PREVOST

WARRANTY BULLETIN

WB15-48A

SUBJECT: BITZER – ADDITION OF A REINFORCEMENT

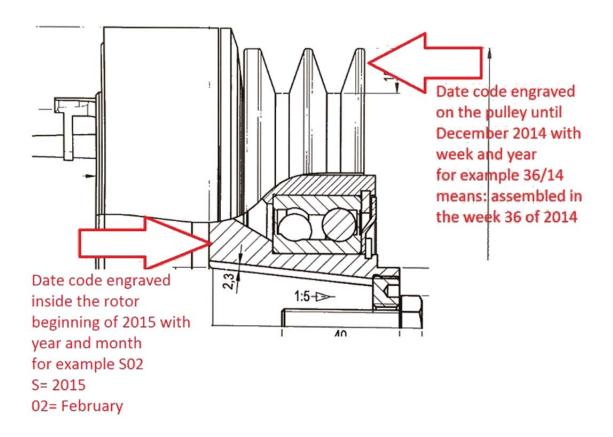
- 7.4. Loosen the fastening screws (4x) of the coil and pull the coil off the retainer.
- 7.5. Check the date code on the clutch pulley. If it is before S05 (May 2015), a new coil #950533 with date code starting from S05 (May 2015) will have to be installed in replacement of this one. (CLEAN POINT IS MAY 2015).

Do not install the clutch at this step. This will be done further in the bulletin.

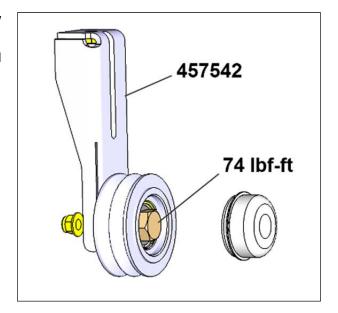
Note: If bolts **C** & **E** are difficult to drive in hole, the compressor may be moved slightly to allow assembly. Loosen the compressor mounting bolts (4x) at the base.

Once installed, tighten compressor mounting bolts to **74 lbf-ft.** (100 N-m)

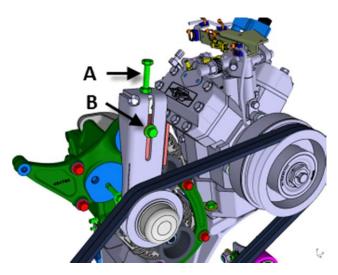
On vehicles equipped with an auxiliary alternator (i.e. 2 different belts), the belts tension should be within this range:

A belt strand tension gauge is needed 150-160 lbs <u>new</u> belts (mean of 2 belt values)

120-130 lbs <u>used</u> belts (mean of 2 belt values)

Adjust belt tension using bolt (A). Use the jam nut to prevent rotation of bolt (A). When proper tension is achieved, tighten bolt (B) to 43 lbf-ft. (58 N-m)

UNLOADER COIL REPLACEMENT

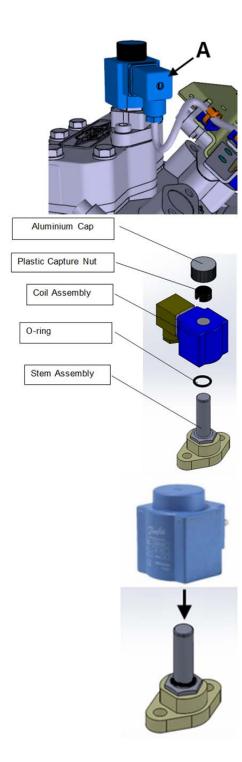
A new "clip-on" type unloader coil must be installed in order to avoid unloader failure.

- Loosen the screw securing the connector to the coil and then unplug the connector (A). Keep the screw and the connector rubber gasket for later use.
- 2. Unscrew the aluminum cap and discard.
- 3. Remove the plastic capture nut and discard.
- 4. Remove the coil and discard
- 5. **Keep** the O-ring on the stem.

- 6. Install the new clip-on coil on the stem.
- 7. Slide the coil over the stem assembly with the O-ring at the base of the stem.

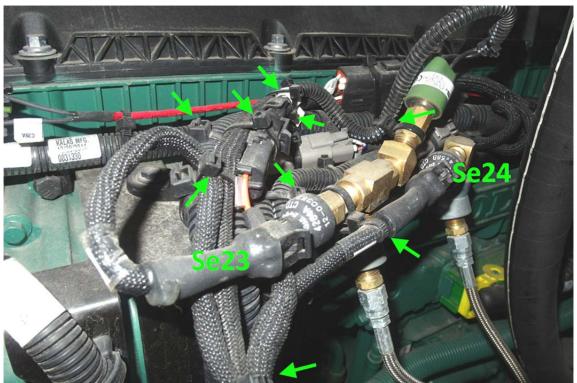
- 7. According to table, splice wires with butt slice #562228. Crimp and solder. Inspect to make sure you have a good crimp and solder.
- 8. Seal each wire with shrink tube. Seal over the two wires and cable isolation with shrink tube.
- 9. Attach clutch cable along bracket as shown.

ATTACH THE EXCESS LENGTH OF CABLE ALONG MAIN STRAND OF HARNESS AS SHOWN- NYLON TIES LOCATION SHOWN BY ARROWS

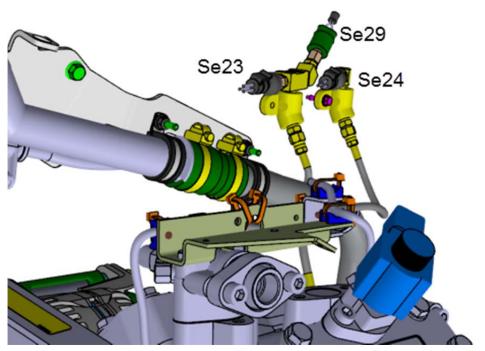
ATTACH THE EXCESS LENGTH OF CABLE ALONG MAIN STRAND OF HARNESS AS SHOWN- NYLON TIES LOCATION SHOWN BY ARROWS

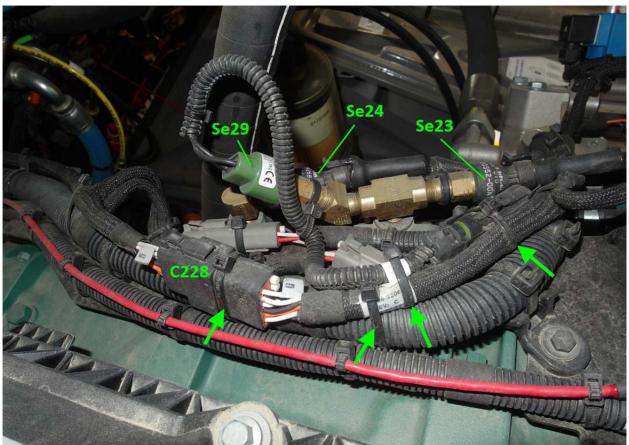
ATTACH THE EXCESS LENGTH OF CABLE ALONG MAIN STRAND OF HARNESS AS SHOWN- NYLON TIES LOCATION SHOWN BY ARROWS
